RECOMMENDATION REPORT

CASE NUMBER: PRP-18-0001

RE: Brook Valley II Business Park Replat Five
City Engineer Initial Review of Replat Submittal

RE: Replat Application – 2nd Review
Brook Valley II Business Park Replat 5

PRELIMINARY PLAT

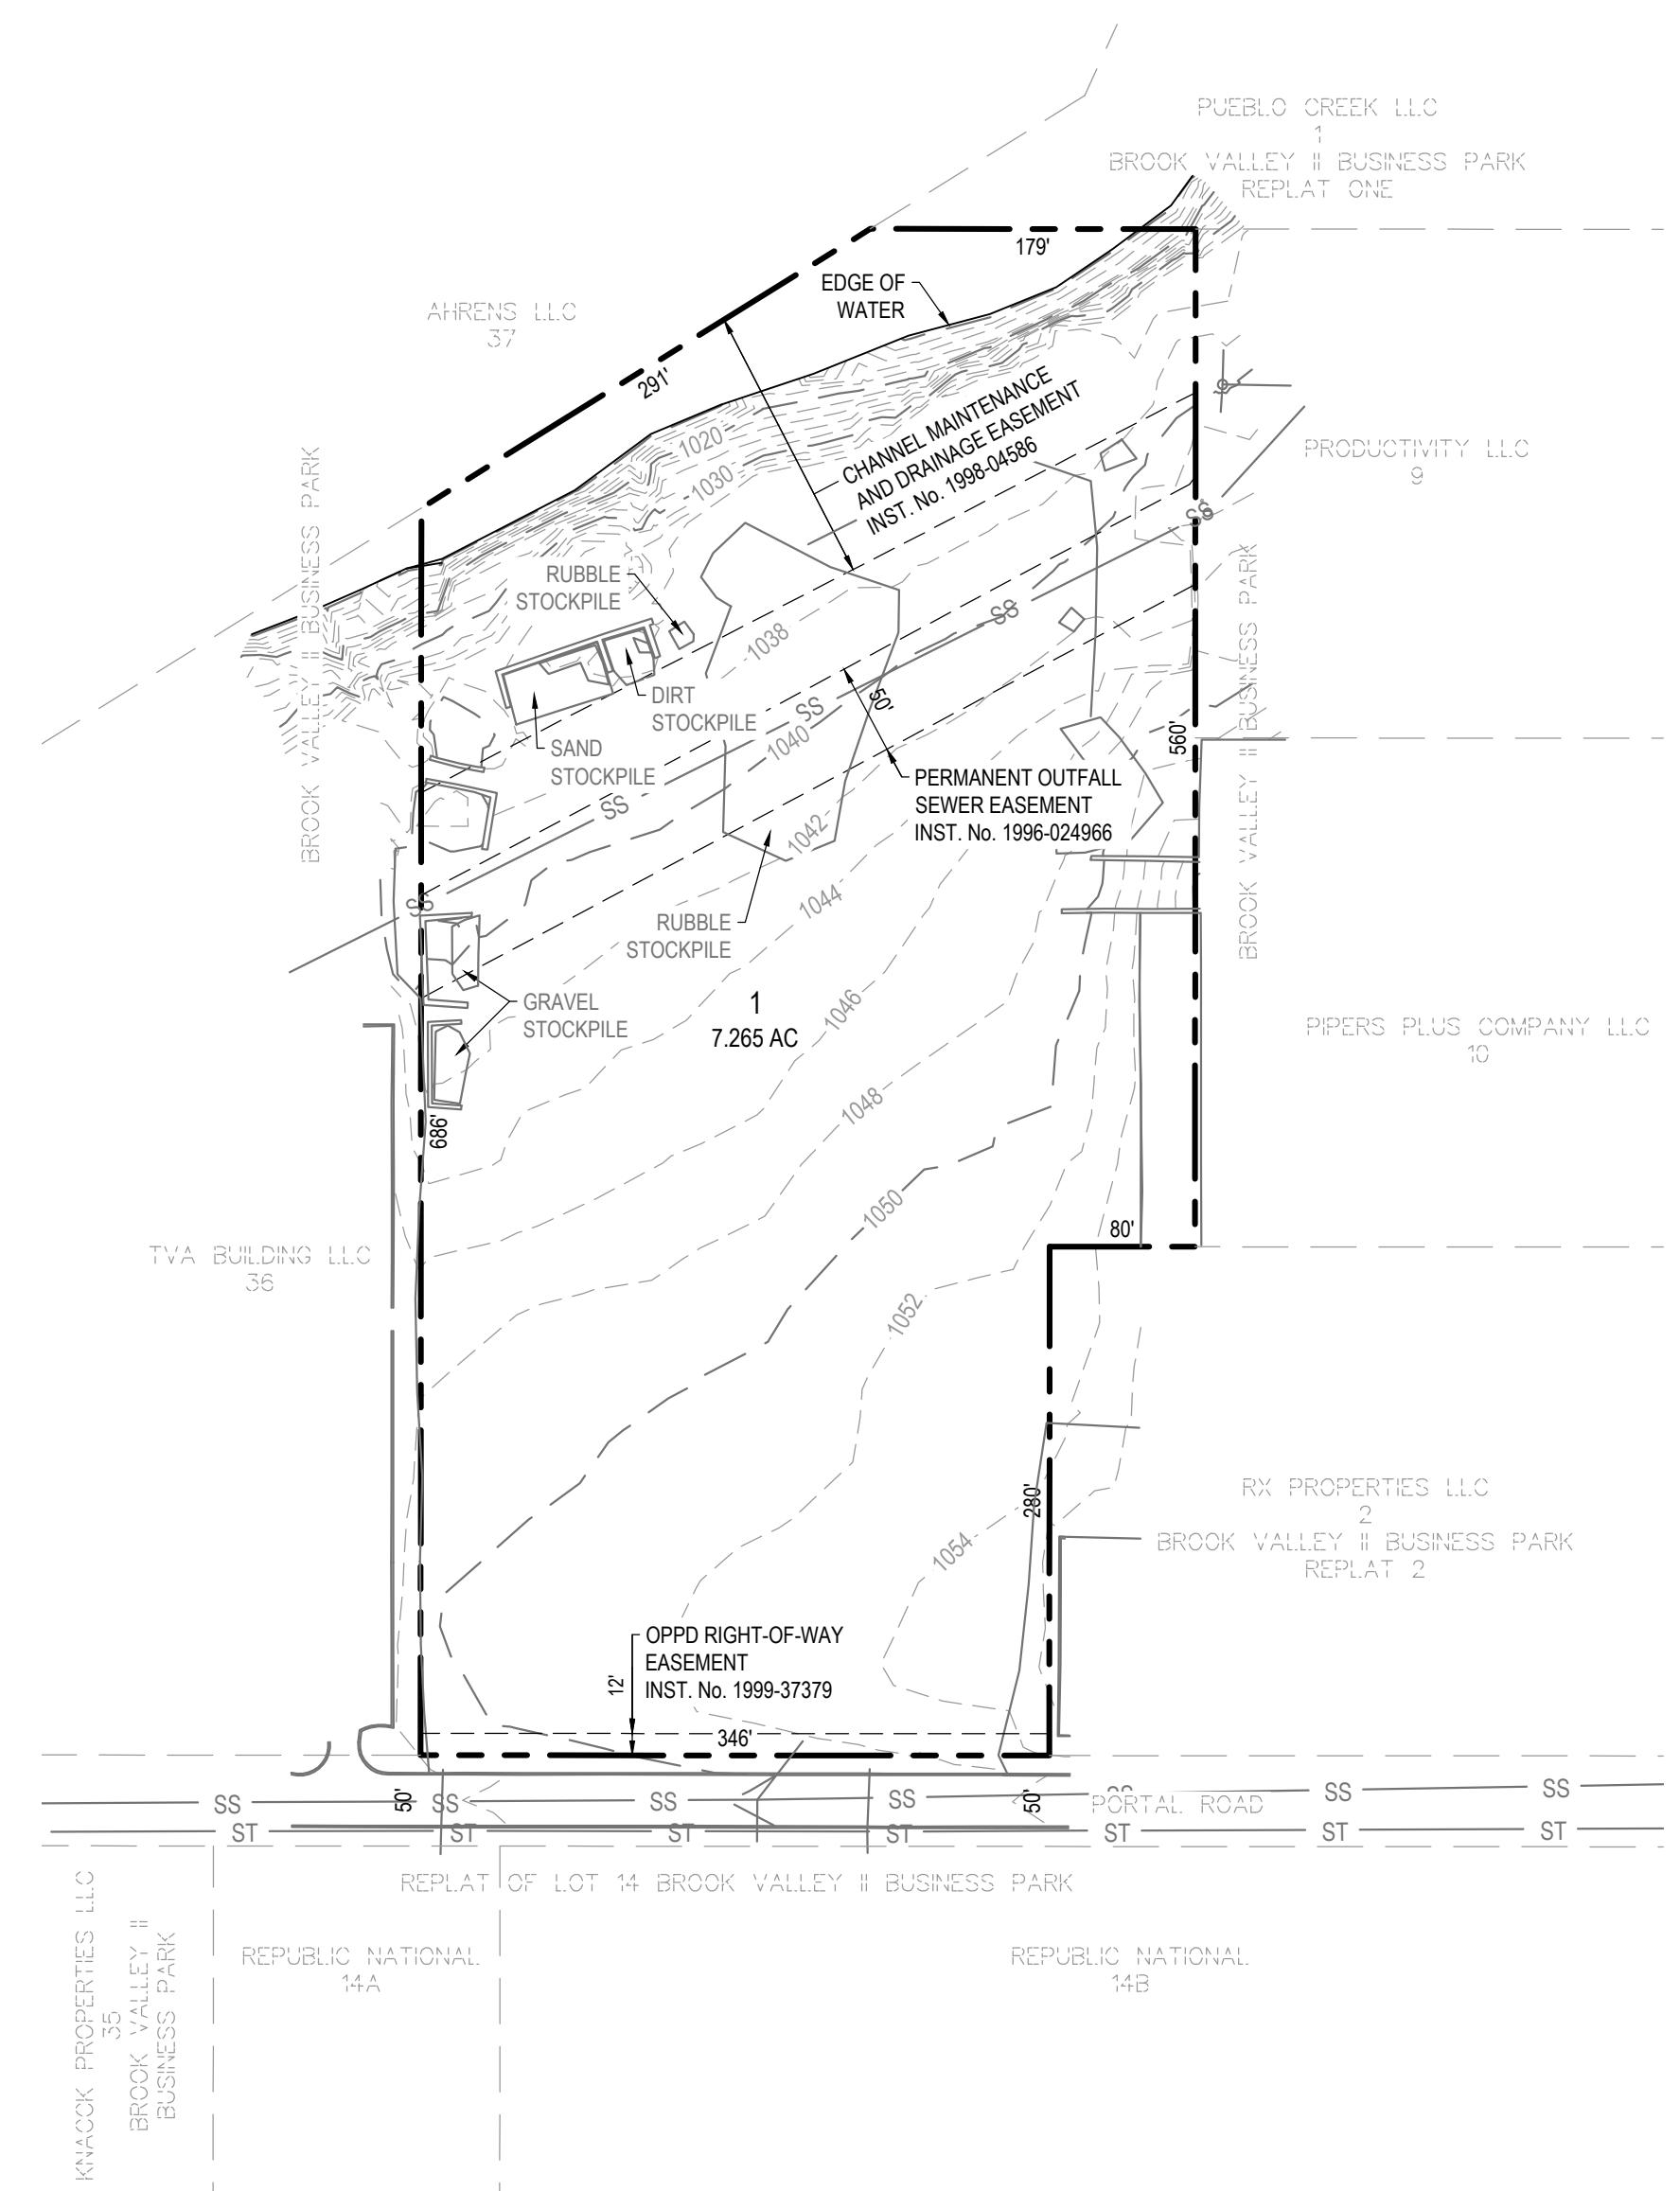
1. On the Preliminary Plat drawing please add an index listing the other sheets that were submitted that comprise all the preliminary plat information. This would be the Site Utility Plan and the Site Grading Plan.

Response: The preliminary plat has added a sheet index to the drawing.

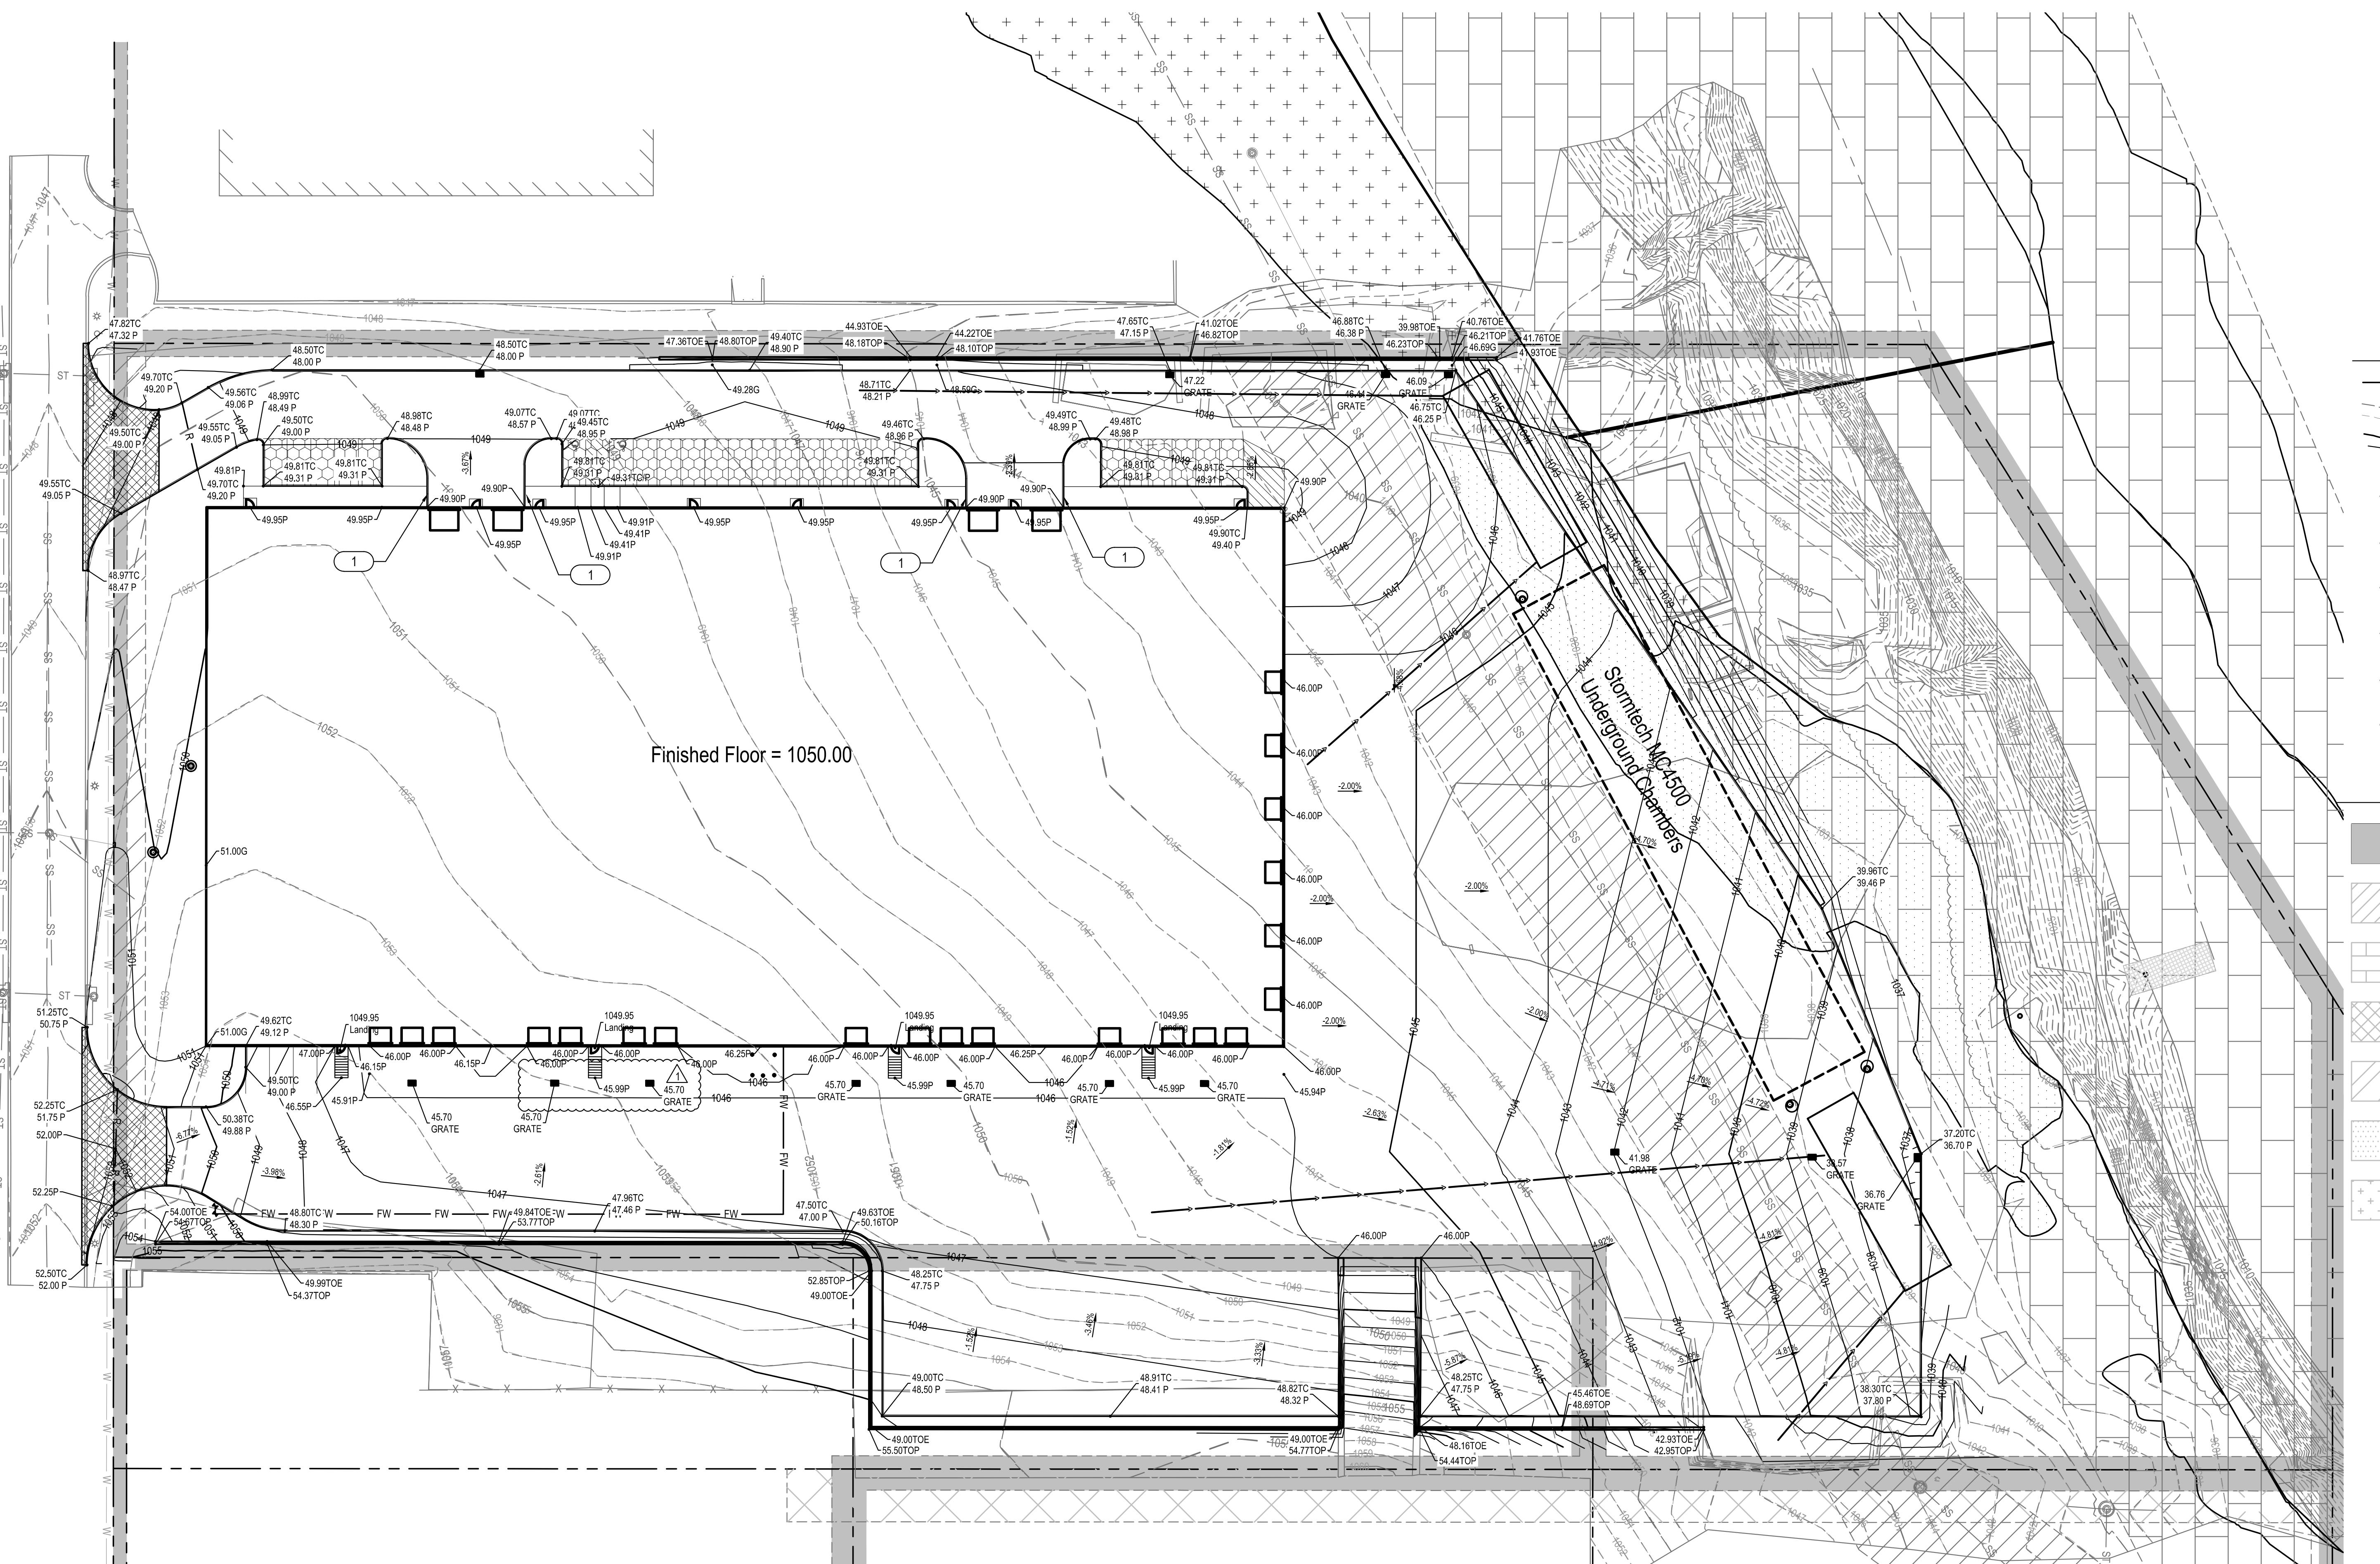
2. The Site Grading Plan indicates that there will be a vehicular connection to Lot 10, Brook Valley II Business Park. That raises the possibility of Lot 10 and proposed Lot 1 being in different ownerships in the future and potential issues with reciprocal access. There needs to be an easement addressing ingress/egress between these lots which would address rights and responsibilities.

Response: We acknowledge the need to address the ingress/egress concerns between the two lots and we will provide a draft agreement for city staff to review at a later date.
